RE: Contract 20160030  
Samuel Myers Park Restorations – Phase III  
A.W. Oakes & Son, Contractor

Submitted for your review and approval is Change Order No. 1 on the subject contract. Change Order No. 1 is in the amount of \$3,227.00.

**PRELIMINARY - NOT FOR CONSTRUCTION**  
**EAST DIKE REPAIR**

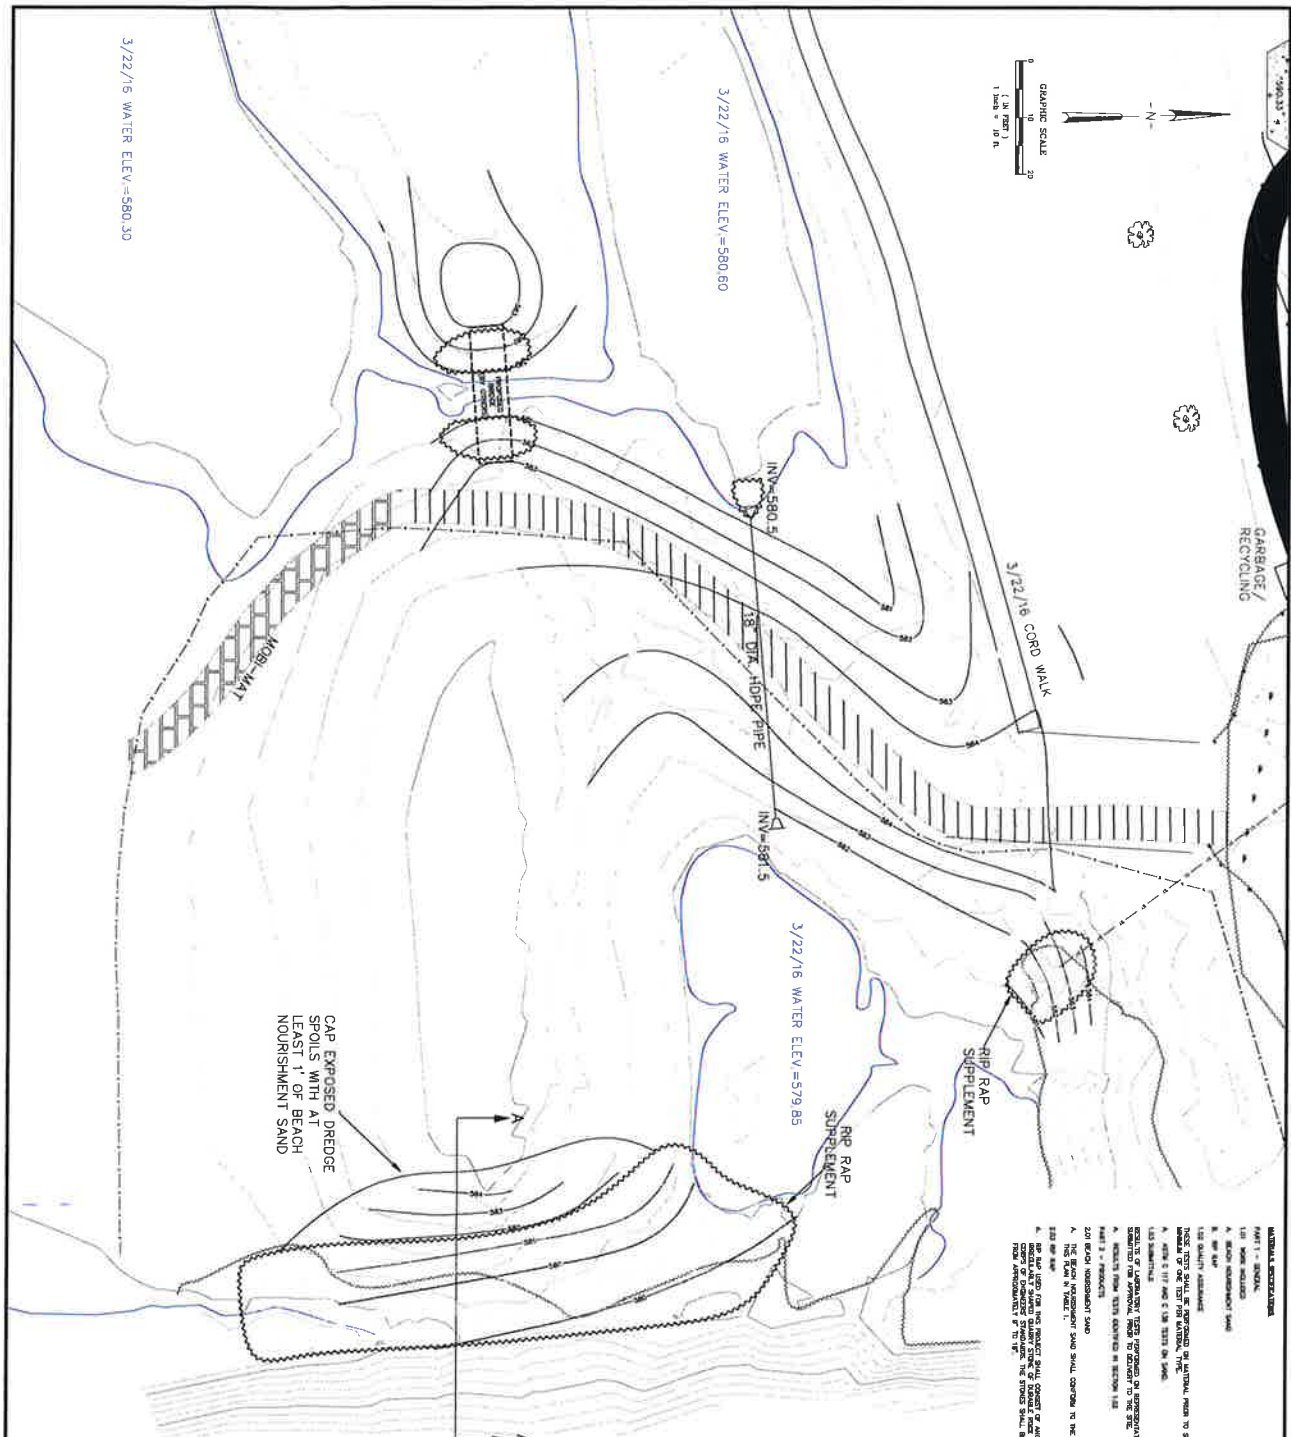
This change order is needed to supplement east/middle dune features to accommodate a walkway, add geotextile cloth and 9 – 16” quarry stone for erosion control and additional sand to meet final grades due to compaction.
